| APPLICATION NO. | FILING DATE | FIRST NAMED INVENTOR | ATTORNEY DOCKET NO. | CONFIRMATION NO. |
|-----------------|-------------|----------------------|---------------------|------------------|
| 09/531,735 | 03/21/2000 | Shalom Levin | EPLC/03 | 7129 |

Office Action Summary

DETAILED ACTION

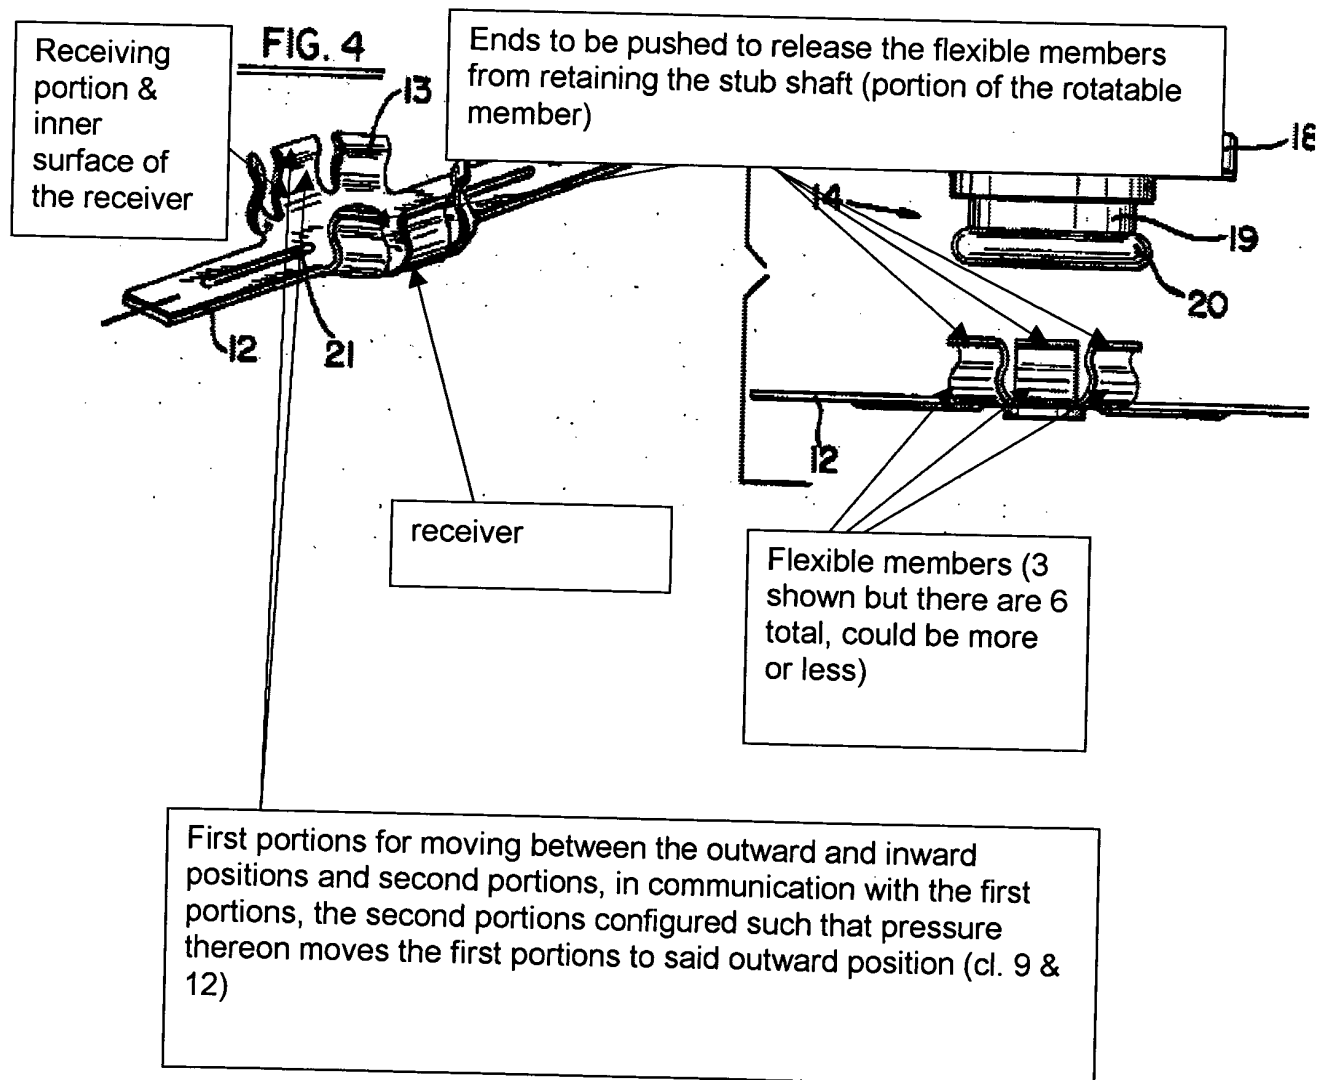
In re independent claims 9 & 12, Weber discloses as also shown in the marked up figures below, a lawnmower blade assembly comprising:

a shaft (15) rotatable with a motor (10);

a stub (19, 20) in communication with the shaft (fig 2);

a blade (12);

a receiver (22) coupled to the blade (fig 4, 5), the receiver including a receiving portion (13) and at least a plurality of flexible members (13) configured for moving between outward and inward positions for engaging and retaining the stub in the receiving portion (fig 2) in a releasable engagement, the flexible members including ends configured such that pressure thereon moves the flexible members outward, allowing for at least the disengagement of the blade from the stub (as the top ends of flexible members of the receiving portion is moved outwardly the receiver is released from the stub shaft);

in re independent claim 12, Weber discloses a lawnmower blade assembly comprising:

- a shaft (15) rotatable with a motor (10);

- a stub (19, 20) in communication with the shaft (fig 2);

- a blade body (12) including oppositely disposed cutting portions (fig 6, blade 12 having oppositely disposed cutting portions) and a platform intermediate the cutting portions (as best shown on fig 4, the receiver is placed between the oppositely disposed cutting portions or in the middle of ref 12);

- a receiver (22) coupled coaxially to the blade (fig 4, 5), the receiver including a receiving portion (13) and at least a plurality of flexible members (13) configured for moving between outward and inward positions for engaging and retaining the stub in the receiving portion (fig 2) in a releasable engagement, the flexible members including ends configured such that pressure thereon moves the flexible members outward, allowing for at least the disengagement of the blade from the stub (as the top ends of flexible members of the receiving portion is moved outwardly the receiver is released from the stub shaft);

In response to Applicant's argument that Weber does not have "ends or second portions" (the first and second portions were added with the 8/20/03 amendment), is not agreed with, for demonstration purposes the Examiner provided a marked up drawings showing the first & second portions above.
